# UNITED STATES PATENT AND TRADEMARK OFFICE

10/586,983

<b>Office Action Summary</b>	<b>Application No.</b>	<b>Applicant(s)</b>	
	10/586,983	SCHEMPP ET AL.	
	<b>Examiner</b>	<b>Art Unit</b>	
	OMAR ROJAS	2874

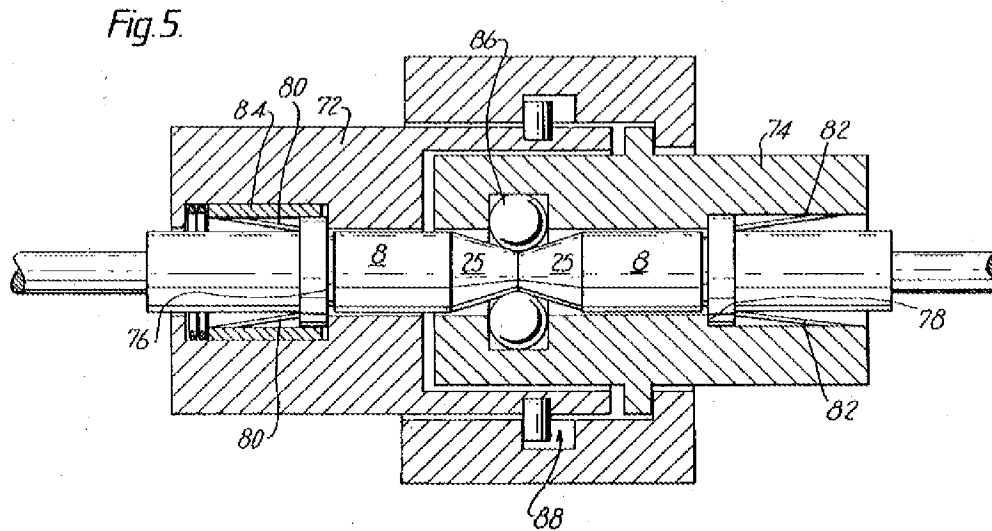
said mating receptacle **72/88** including at least one sleeve **74** forming a channel holding front end **25** that and a channel extension holding spring **82** adjacent to one another along a stop surface (the surface abutting flange **26**) for said complementary optical terminal element,

said channel and channel extension forming a channel axis to be coincident with said optical axis of said complementary optical terminal element **2/8**, when the same is mated with the optical connector,

said channel extension being formed with clamping springs **82**, and at least one optical fiber section **8**, said at least one optical fiber section **8** having a front end **25** with a front optical contact surface and a rear end (i.e., the other end of optical fiber **2** not shown in the figures) with a rear optical contact surface, said optical fiber section **8** being affixed in said channel extension of said fiber receiving sleeve **74** by means of said clamping springs **82**, and being positioned to establish, with said front optical contact surface, an optical connection to said complementary optical element **8** of said complementary connector,

wherein said clamping elements **82** define a narrowing opening in said channel extension (as seen in Fig. 5) of said fiber receiving sleeve **74**, longitudinally spaced from said front side of said fiber receiving sleeve and arranged with a set-back relative to said front optical contact surface such that said front end **25** of said optical fiber section extends beyond said narrowing opening in said channel extension of said fiber receiving sleeve **74** adjacent to said complementary optical terminal element **8** of said complementary connector. *See* columns 3-5 of Lidholt for further details. Figure 5 of Lidholt is reproduced below.

*In re* claims 28, 29, 31, these particular limitations are clearly apparent from Figure 5 of Lidholt.

*In re* claim 30, the clamping springs **82** of Lidholt are inherently capable of engaging said optical fiber section **8** and displacing and compressing said fiber section **4** because they appear to have the same physical structure as the claimed clamping elements.

*In re* claims 35 and 36, Lidholt's channel extension inherently includes a front section and a rear section as seen in Figure 5. Lidholt only differs from claims 36 and 36 in that he does not teach that his sleeve **74**, in the region of said channel extension, has an inner diameter of 40  $\mu\text{m}$  smaller to 120  $\mu\text{m}$  larger than the exterior of the optical fiber section **8** and/or provides a radial clearance of 40  $\mu\text{m}$  to 100  $\mu\text{m}$  for the optical fiber section **8**. However, as seen in Figure 5 of Lidholt, the optical fiber section **8** inherently requires some radial clearance between the sleeve **74** in order to fit the flange **26** within the sleeve. Therefore, Lidholt's sleeve would certainly require a larger inner diameter than the exterior of the fiber section **8** in order to accommodate
